Service Bulletin

Bulletin No.: 13-06-01-003B

Subject: Excessive Oil Consumption – Perform Oil Consumption Test and/or Install Piston and Piston Ring Kit

Models: 2010-2013 Buick LaCrosse
2011-2013 Buick Regal
2010-2013 Chevrolet Equinox
2010-2013 GMC Terrain
Equipped with 2.4L Engine (RPOs LAF, LEA)

Acceptable Cylinder that Does Not Appear Uniform (Zebra Stripes)

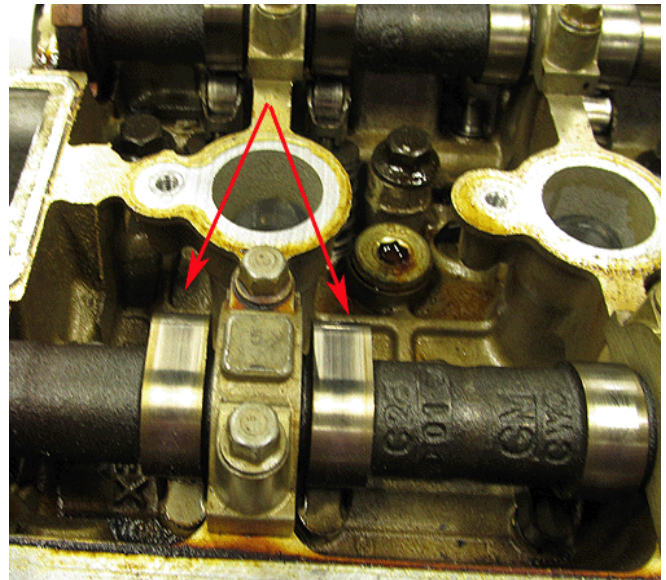
The repair is to replace the pistons and rings. In some cases the bore surface may not have a uniform look to the finish (zebra stripes) as shown below. As a result, some technicians may question whether the engine should be repaired or replaced. After careful evaluation, GM Powertrain has determined that the new pistons and rings will perform correctly in bores that have this appearance so engine replacement should not be

necessary. The cylinder bores do not need any machine or honing work performed on them. Refer to the picture below for acceptable surface finishes.

3409678

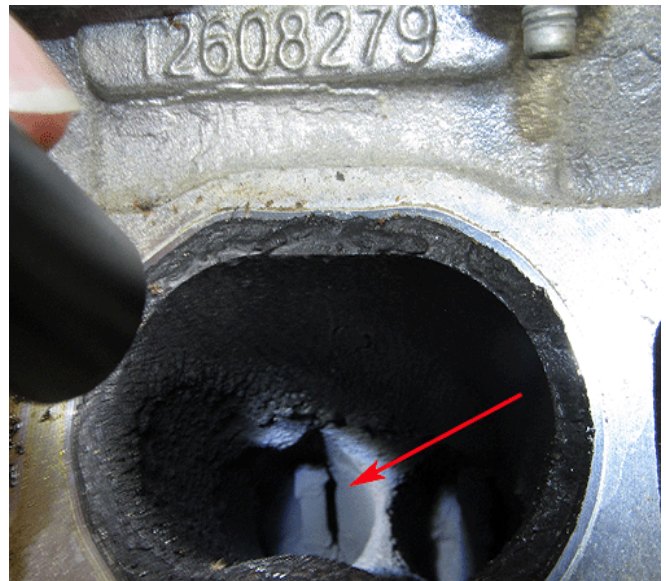
Note: Returned oil consumption engines have been reviewed at engine tear down. It has been determined that these components do not need to be replaced.

- Camshafts and roller follower will have wear markings. This is normal and do not need to be replaced (refer to picture above).
